SUSPENSION—HARSH RIDE—SUSPENSION SITS LOW IN FRONT	Article No. 02-21-16

FORD: 2003 CROWN VICTORIA

MERCURY: 2003 GRAND MARQUIS

Figure 1 - Article 02-21-16

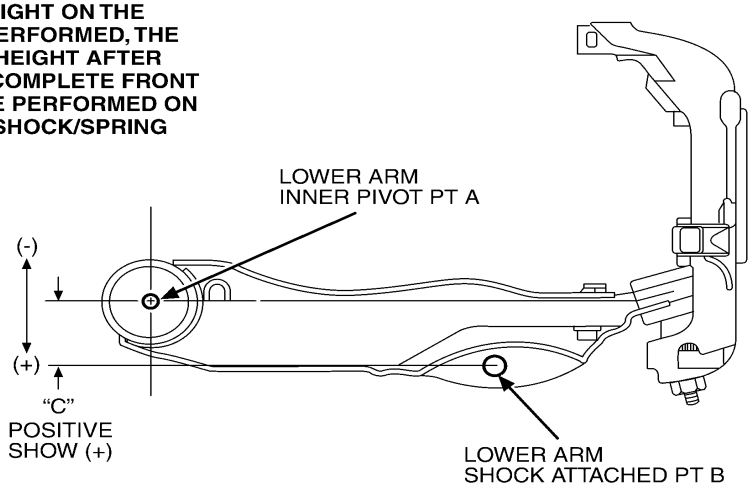
Some vehicles may appear to have a harsh ride in the front end of the vehicle. This may be caused by the front springs.

1. Verify that the vehicle is low in the front by measuring the ride height "C" dimension, at curb height. At curb condition the vehicle should have full fluids but no additional weight of passengers or luggage.

a. Measure the distance from the Lower Control Arm (LCA) inner pivot point A (bolt center) to the ground.
    b. Measure the distance from the shock attachment B (bolt center) to the ground.

c. Subtract b. from a. and the front ride height should be at a minimum of 60 mm. (Figure 1).
3. If the vehicle is below 63 mm but above 57 mm, remove existing springs and replace with 3W1Z-5310-EA. Refer to Section 204-01 of the Workshop Manual for replacement procedures.

Replace the existing springs with revised springs. The revised springs provide a higher ride height at curb and reduce the possibility of the front being too low. Refer to the following Service Procedure for details.

4. If the vehicle is below 57 mm, remove existing springs and replace with 3W1Z-5310-HA. Refer to Section 204-01 of the Workshop Manual for replacement procedures.

FINAL SPRING BUSHING TORQUE MUST BE PERFORMED AT CURB WEIGHT ON THE VEHICLE. IF THIS IS NOT PERFORMED, THE VEHICLE MAY LOSE RIDE HEIGHT AFTER LOADING/UNLOADING. A COMPLETE FRONT END ALIGNMENT MUST BE PERFORMED ON THE VEHICLE AFTER THE SHOCK/SPRING INSTALLATION.
